Planning App Ref:	PL/2026/02177
Service Ref:	Drainage
Date:	27 May 2026

Prior Approval Part 3, Class MA: Commercial, business and service uses to dwellinghouses:
Conversion of building into 6 flats comprising 3 x 3 beds and 3 x two beds - No external changes to the external facades is anticipated

Boreham Mill, Bishopstrow Road, Warminster, Wiltshire, BA12 9HQ

Figure 1

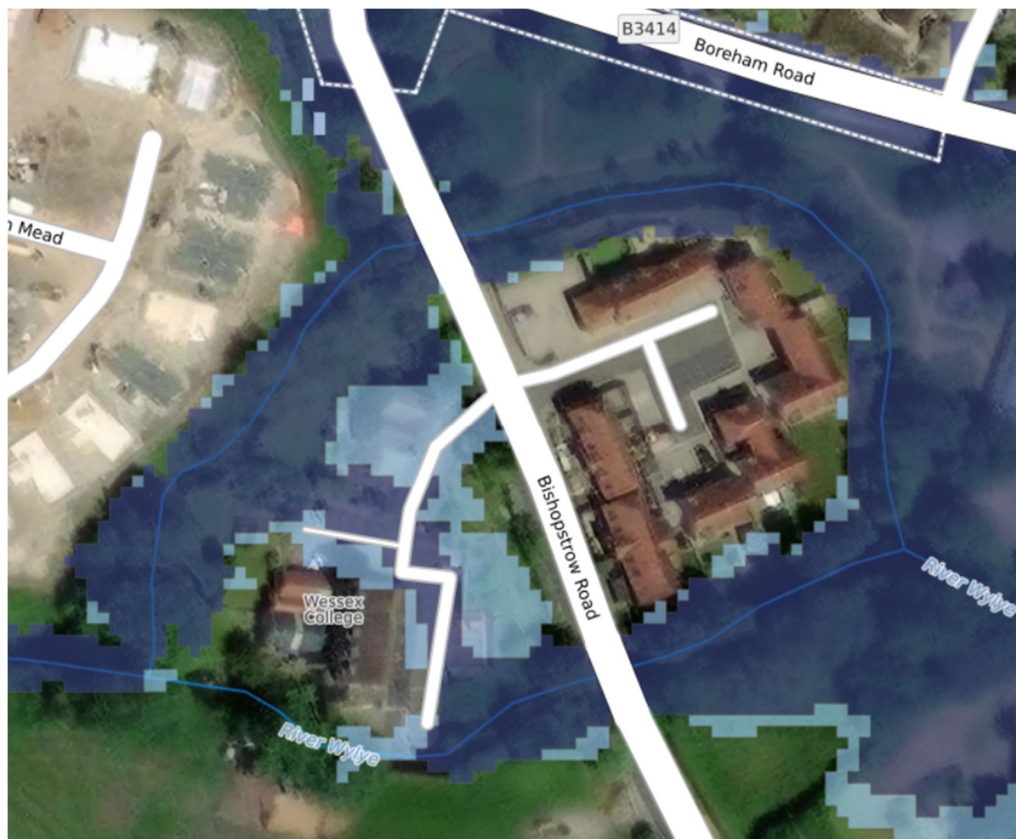
A review of the EA RoFRS (Figure 1) shows that when considering the impacts of climate change, the flood polygons overlap the building footprint indicating that the site will be at risk of fluvial flooding in the future and would be completely cut off by Fluvial Flooding during an event.
